Upper Gwynedd Township

Re: Change order #1 – Schipsi Electric

Change Order

Supplemental Instructions

1 PARTIAL FIRST FLOOR POWER PLANS - CSK - E01
1/4" = 1'-0"

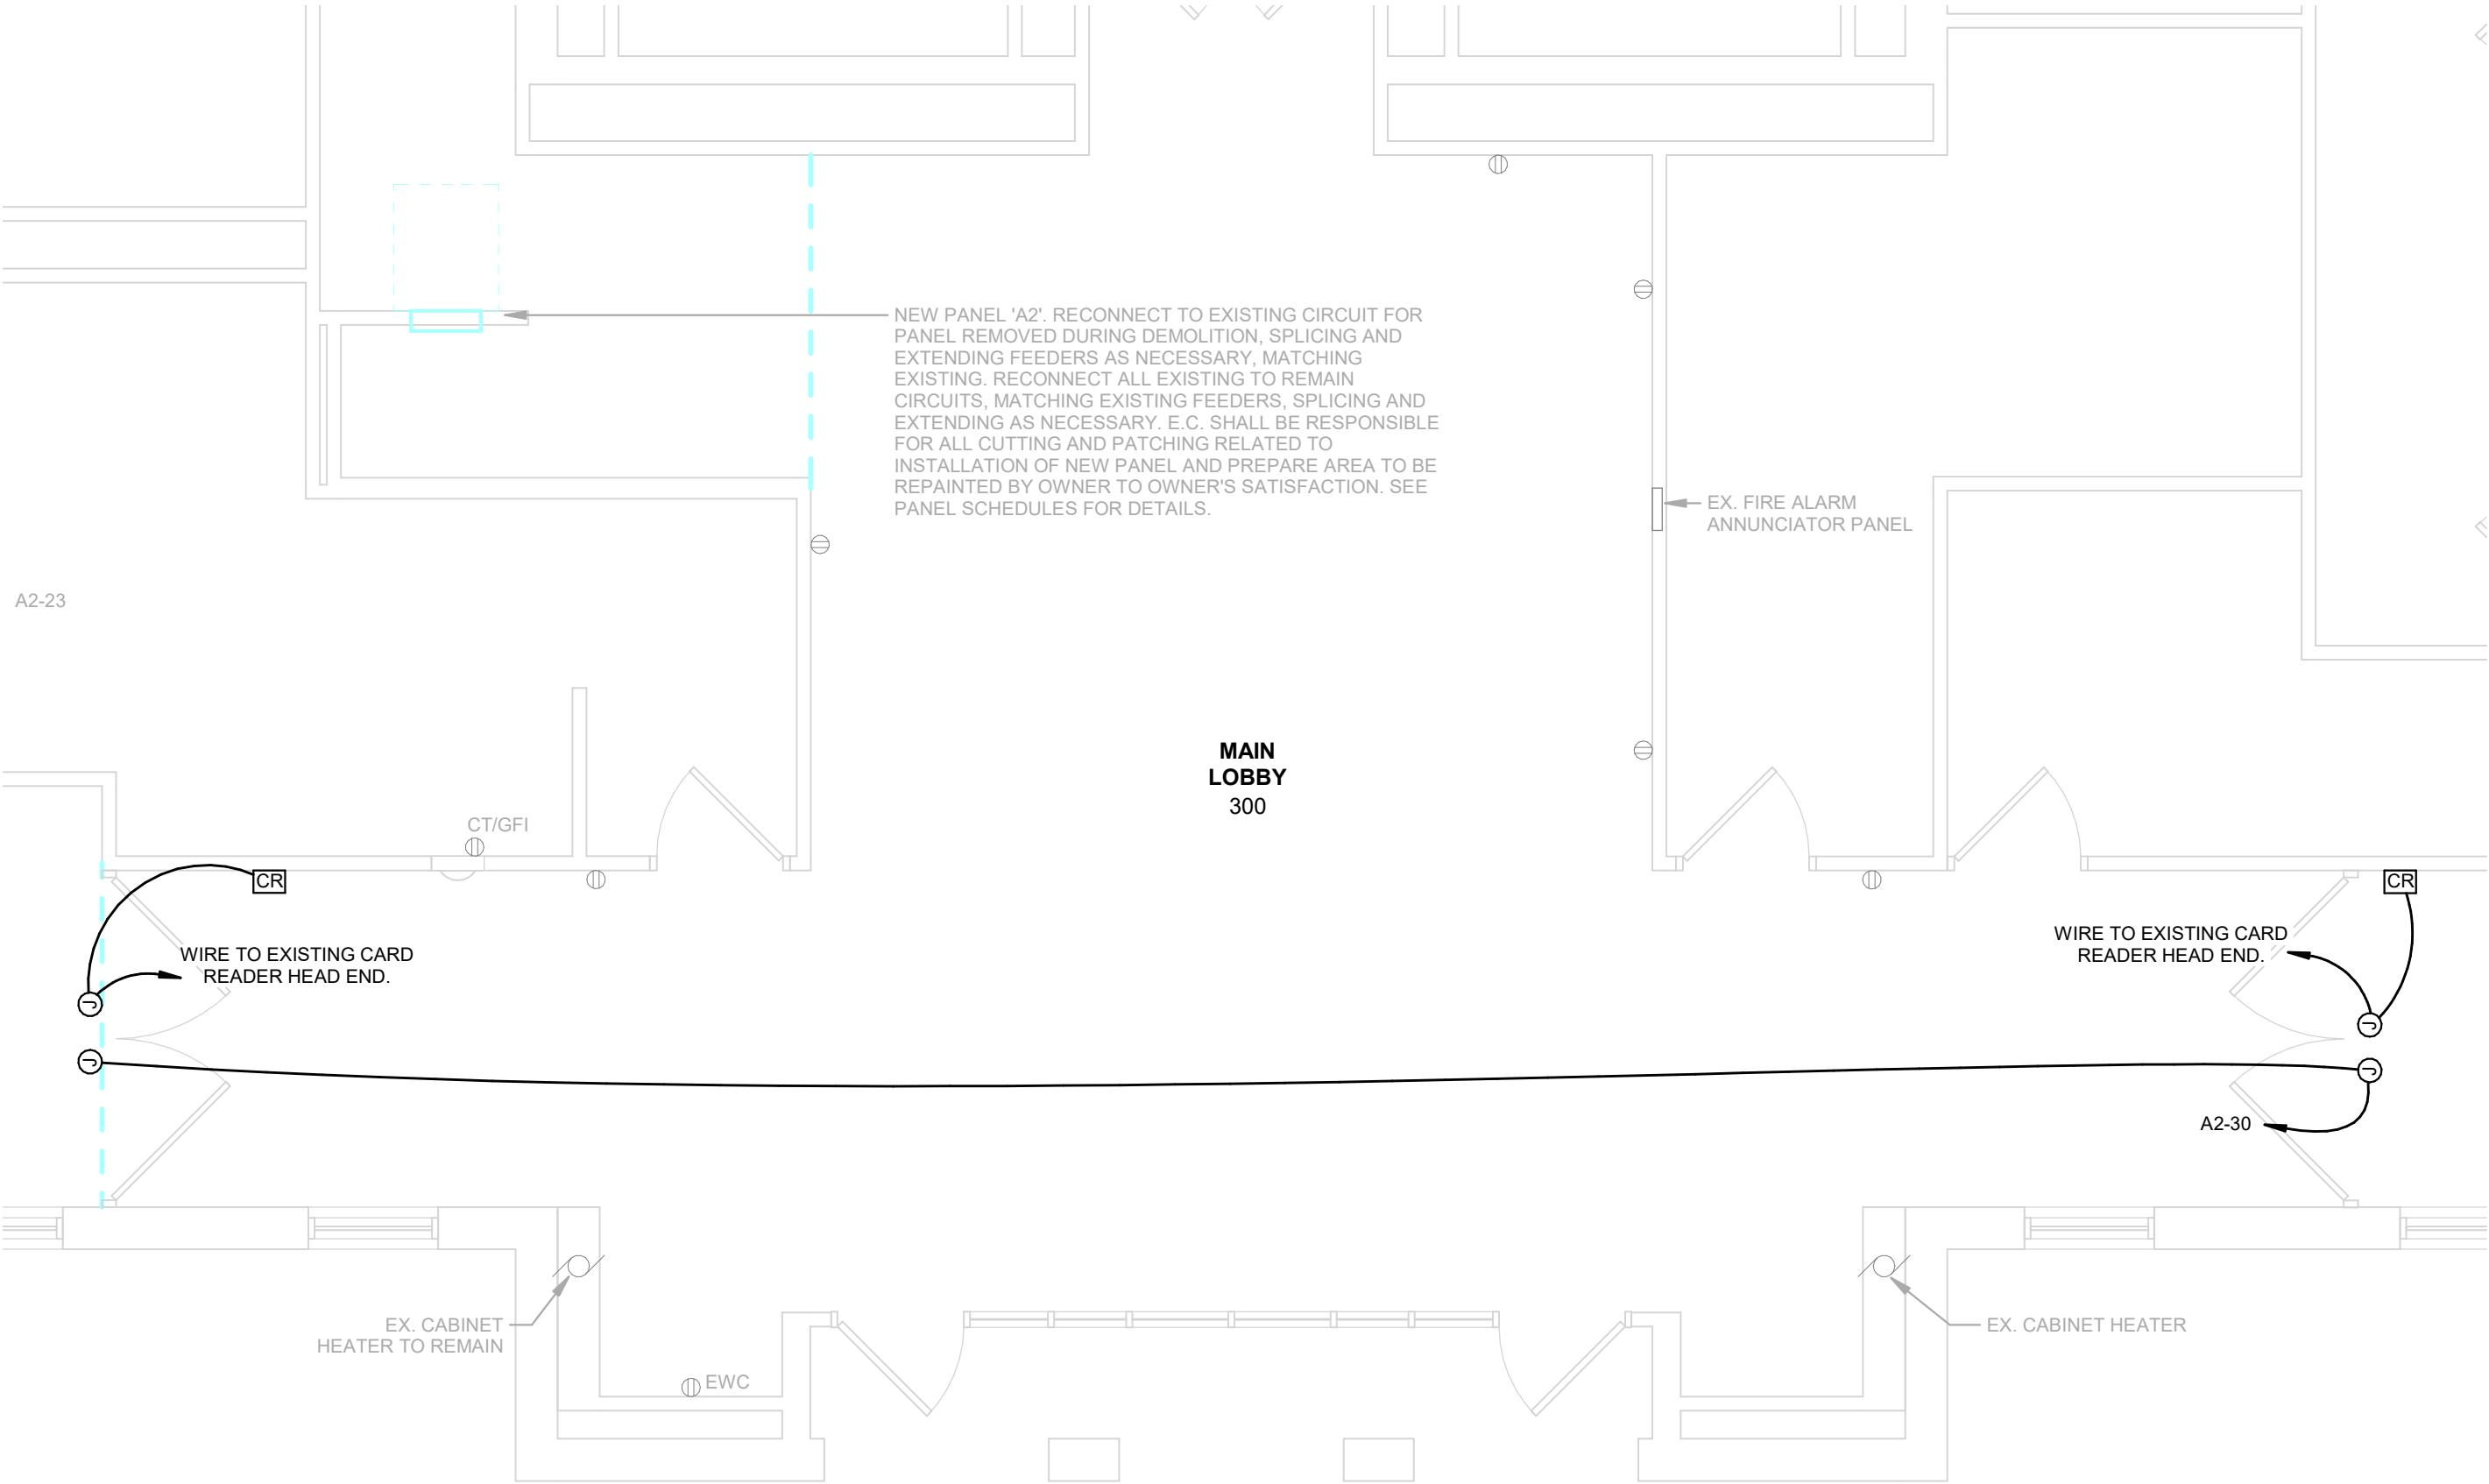
DESCRIPTION: ADDITIONAL CARD READERS AND ASSOCIATED INFRASTRUCTURE

Refer to attached sketch CSK-E01 for the addition of card readers and associated infrastructure requested by the Township at (2) pairs of doors in Main Lobby 300.

EC shall be responsible for scope of work indicated in the attached CSK-E01 and integration of electrified hardware components with required power infrastructure. Card reader equipment to match existing and integrate with existing building wide access control system. EC coordinate with Township to confirm details of existing access control system.

GC and EC shall coordinate door hardware, access control and other infrastructure requirements to ensure fully operational door assemblies.

GC to provide the following hardware at each pair of doors. GC field verify existing conditions to confirm compatibility of hardware with existing door assemblies.

- Surf. Vert. Rod Exit 9827L x E996L-07 x US4
- Surf. Vert. Rod Exit Only 9827-EO x US4
- Wire Harness Con-12
- Wire Harness Con-192P
- Power Supply PS-902
- Cylinder Housing 20-079 x US4
- Mk'd Cores 20-740 x 606
- External Power Door Loop TSB-C
